## 4S Santa Fe Valley Mega-Project Abatement Coalition

**Subj:** Comments to DSEIR

**Ref:** Chinese Bible Church of San Diego  
PDS2014-SPA-14-001, PDS2010-3300-10-037(MUP), PDS2012-3940-12-002(VAC),  
PDS2010-3910-9508007L(ER), SCH# 214011018

## Proposed Use Incompatible with Adjacent Uses

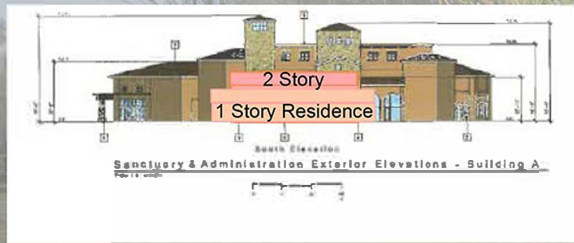
O-5-11

Proposed	Type	Adjacent	Compatible?
Church	Civic	No	No
Pre-school	Civic	No	No
Café	Commercial	No	No
Bookstore	Commercial	No	No
Residence	Residential	Yes	No
All of the above	All	No	No

↪ There are no other properties in the SFVSP that comprise a combination of commercial, residential and civic uses  
 ↪ All other civic uses serve the entire community

**O-5-11** .The comment provides a land use table and notes the proposed use is incompatible with existing uses. Column 3 ignores the fire station, which is an adjacent civic use. The table shows the proposed uses to be church, pre-school, café, bookstore, and residence. No pre-school or residences are proposed by the project. The café and bookstore are ancillary to and are in support of the church function, and are not as such commercial uses such as would be found in Black Mountain Ranch North Village located approximately 550 feet to the southwest. Sleeping accommodations will be provide for congregants who will remain at the facility for days up to a few weeks while they undertake Bible study or participate in symposia or missionary training. These will be guests and the stays will fall within the scope of transient occupation in conformance with County regulations. Column 4 of the table indicates none of the proposed uses are compatible with adjacent uses. Reasoning is not provided so a detailed response is not possible. However, churches are generally considered to be compatible with residential and other civic uses. The comment states there are no other properties that represent a combination of these uses within the SFVSP. The statement provides no specific reasoning as to why this is an undesirable use. Additionally, mixed use is a common use type in the area. These include Maranatha Church, Del Norte High School, and Design 39 School, among others. The comment also states all other uses serve the entire community. This is a subjective statement unsupported by facts. It is not an exaggeration to say that schools, churches, and medical facilities, to name a few, serve the entire communities in which they are located. The project is being sponsored by the Chinese Bible Church of San Diego which is an open church that welcomes visitors and new members alike. The church has stated its café and bookstore, as well as its services, will be open to all.
